# **Quality Control Report**

-	consultant enginee
Site NameAl Khansa'a BaPackagePackage 1ContractorDerar Saraireh 8	anat Consultant Engineers Isic Mixed - Balqa & Sons for Engineering & Contracting	Rep No. QC-12 05 Date 16 / 08 / 2021
Tender No. 1/2020/USAID	/SKEP/3/1	
Description of Non- Conformance	<b>Corrective Action</b>	Required by / When
<ol> <li>Due to thicker points in ceiplastering, part of the mortal fallen down from number of points.</li> <li>Roughness was observed on number of columns.</li> <li>Stone building without usin fixing accessories. And, joints between stones for window sare wider than required. 4. A cabinets installation by destriparts of the built blockworks.</li> </ol>	<ul> <li>Ioose parts, rework in layers.</li> <li>Repairing using the approved materials.</li> <li>at 3. The wrong built stones were removed and replaced with fixing accessories.</li> <li>4. Casting a lintel over the cabinets and casting concrete MEP around where needed.</li> </ul>

Sample of Stone Fixation

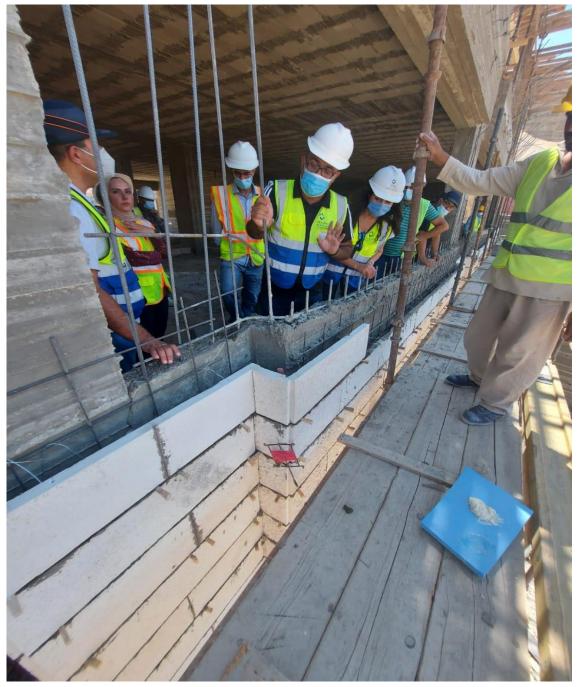
Fixation of Stone at One Area

Report Prepared by	Hassan Shaqbua, Supervision Quality Control Manager	1
Contractor's Posson		
<b>Contractor's Respon</b> The contractor response is sti limited. He rectified the work regarding point 3 and partic for point 4.	 <	
Notes
